Airworthiness Directive Schedule

Helicopters

Airbus Helicopters AS 355 Series

22 December 2022

Figure: Airbus Helicopters recommended CG position of forward two-place seat.

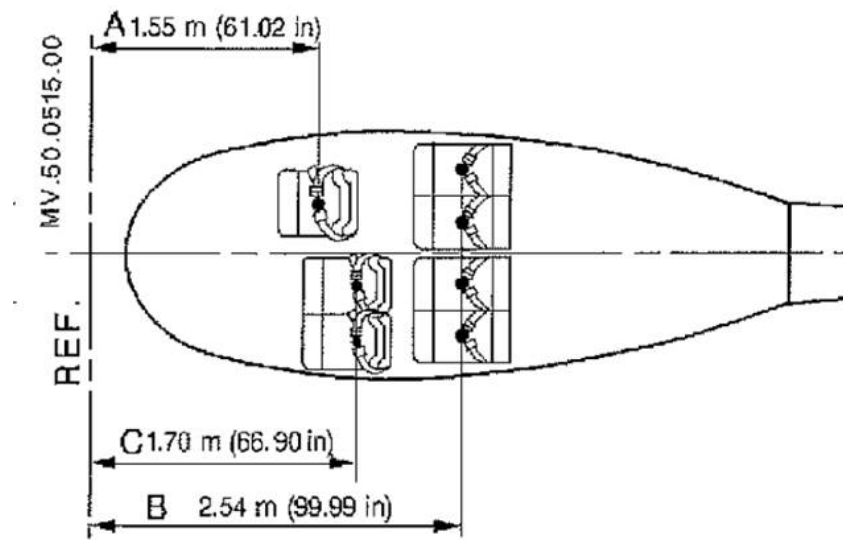
1. Determine the longitudinal moment arm of the forward two-place seat using the center of the seat pan cushion as a measurement reference point.
Complete and issue a new form CAA 2173 Weight and Balance Data.
The weight of the seat components must be included in the CG calculations. If a seat adaptor plate is fitted the moment (position and weight) of the plate must also be considered for the CG calculation.
The lateral CG arm of the helicopter must not be assumed to be zero. The lateral CG must be recorded and be within the limits specified in the AFM.
Annotate the CAA2173 to include the value of the longitudinal moment arm of the forward two-place seat used.
2. Remove CAA Limitations Section, (1 page), dated 14 December 2015 and insert 1 page dated 30 June 2016.

- Compliance:**
1. Before further use of the forward two-place seat, unless previously accomplished.
 2. Before further use of the forward two-place seat.
